Memorandum

Ref. No.: 007878

**Subject: Summary of LNAPL Activities at Malleable Iron Industrial Land
(Dec. 2015 to Nov. 2016)**

figure 1
**PROPOSED MONITORING WELL
ABANDONMENT AND RE-INSTALLATION
RACOR MALLEABLE IRON INDUSTRIAL LAND
Saginaw, Michigan**

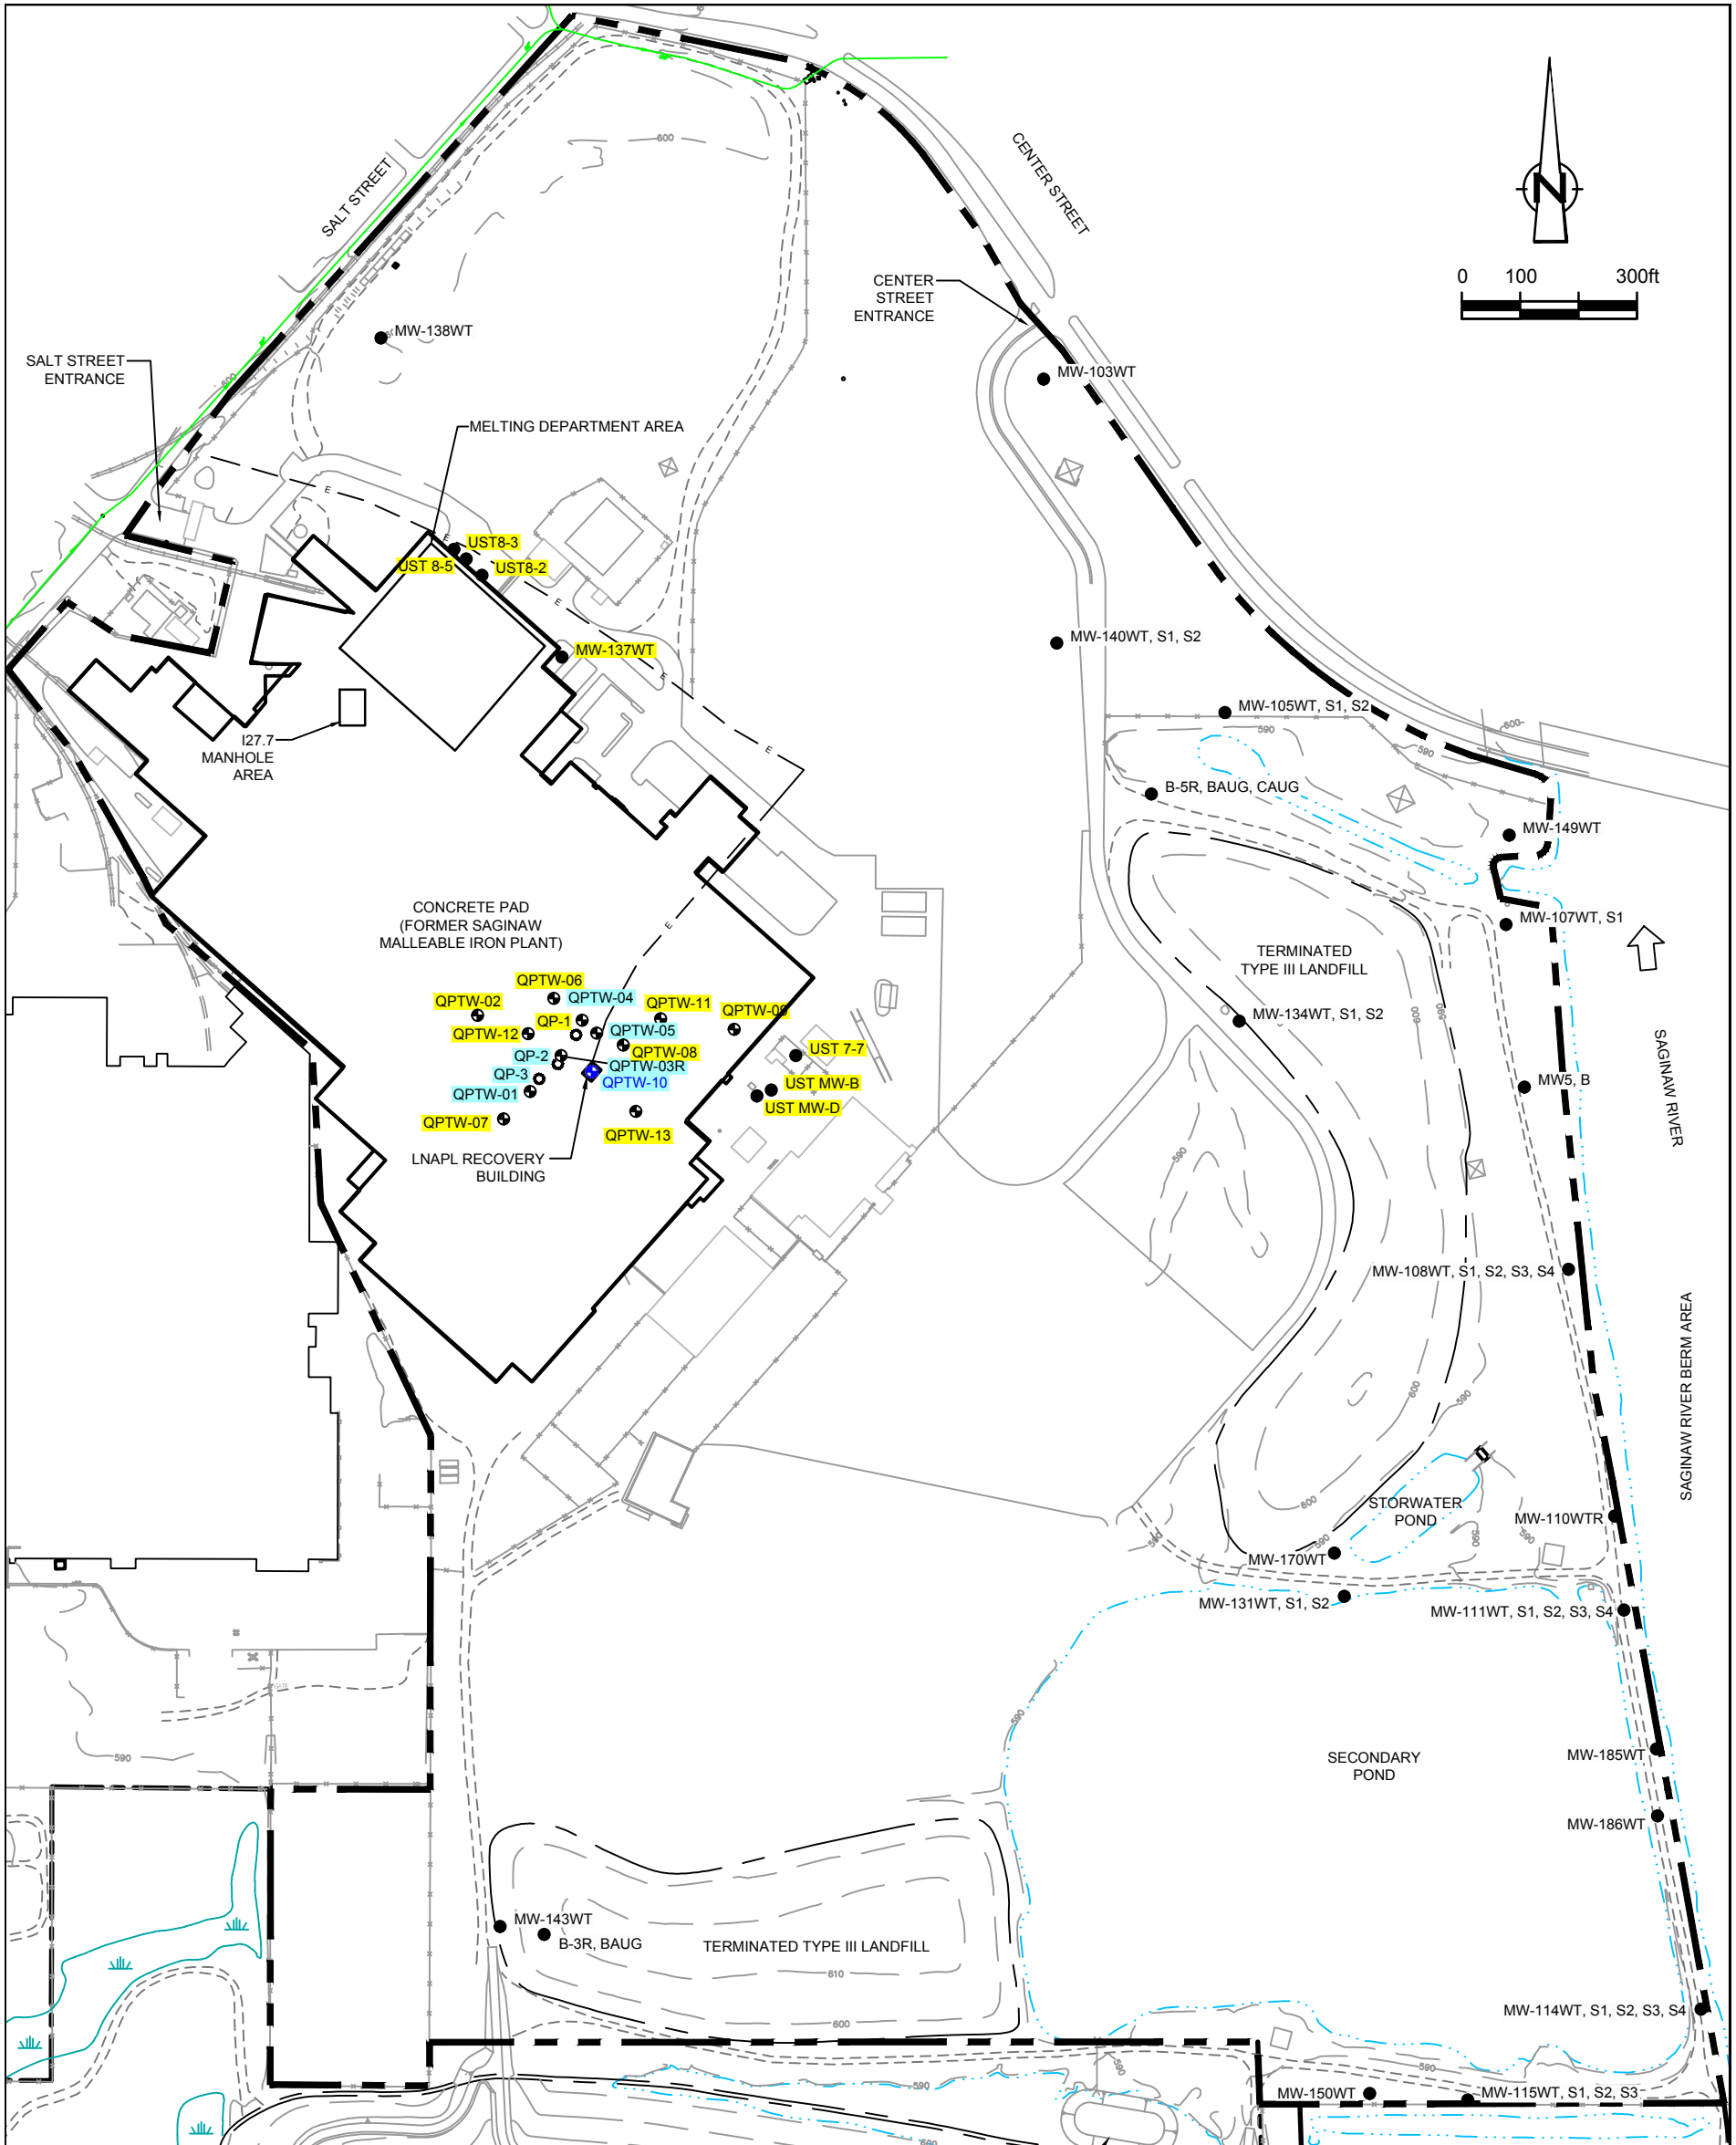
Thank you for the detailed response. We are in agreement with the proposed work with a few exceptions. In addition to the 7 monitoring wells proposed for reinstallation, we would like QP-1 and QPTW-13 to be replaced. QP-1 had NAPL when it was installed and it is situated between two wells that exhibited greater than 2 feet of NAPL in 2015. QPTW-13 is located in the general downgradient direction of QPTW-10 and had NAPL detections as recent as 2013. The well screens are also submerged, so we believe reinstallation is warranted.

Quarterly NAPL monitoring for the replacement wells is acceptable, but only one year of monitoring cannot be approved at this time. If no NAPL is encountered at the completion of one year of monitoring a proposal can be made to discontinue or reduce monitoring. Supporting documentation will be needed to show the disappearance of NAPL was not influenced by fluctuating groundwater elevations or other factors. If NAPL is identified, recovery options need to be evaluated based on thicknesses identified and transmissivity of the wells, etc.

Our last comment is regarding the use of de minimus in relation to transmissivity levels less than 0.5 ft²/day. For clarification, NAPL is not considered de minimus at transmissivity values of 0.5 or less. Having transmissivity values below that level is a means of showing NAPL can no longer be recovered in a cost-effective and efficient manner (which is different than de minimus). De minimus arguments are more appropriate for evaluating the volume and impact of remaining contamination.

I took a look at the wells proposed for abandonment. It looks like you are proposing to replace everything you had NAPL detections in last year, but I have a few questions:

What is the plan for the treatment building/skimmer pump in QPTW-10?

I suspect it may take a while before NAPL starts to accumulate in any new wells. If NAPL doesn't show up right away, how long do you anticipate checking the new wells before you determine no NAPL is present?

The Plan is to move the treatment building/skimmer pump off of the work to allow for concrete removal and installing the soil cover. After the proposed wells are re-installed we propose to complete a transmissivity evaluation of all the re-installed wells. If the transmissivity level is less than the de minimus (0.5), we would propose no further active recovery be completed. If the transmissivity levels in one or more wells is above the de minimus, we would assess the value of continuing LNAPL recovery at that time based on the reasonably expected impact (risk reduction), of recovery on the residual LNAPL body. The building and skimmer pump will remain on-site as long as quarterly monitoring continues until MDEQ approve their complete removal from the Site.

As the screens of the Quench Pit wells we are proposing to abandon are all at or below the water table we do not believe it is appropriate to try to extend the wells and based on experience it is very difficult to keep wells from being damaged during construction activity as is planned for the well locations.

Please see the attached figure which identifies those wells proposed for abandonment (highlighted in yellow) and those monitoring wells proposed for abandonment and re-installation (highlighted in blue). The monitoring wells selected to be re-installed have had historical and/or current presence of LNAPL. At this time, we do not believe re-installation of wells for delineation or verifying no migration is necessary, since NAPL was deemed "effectively immobile, unrecoverable, and stable/non-migrating overall in the bulk of the soil matrix" (November 2014 NAPL presentation). In total there are 23 monitoring wells that would be abandoned and 7 monitoring wells that would be re-installed.
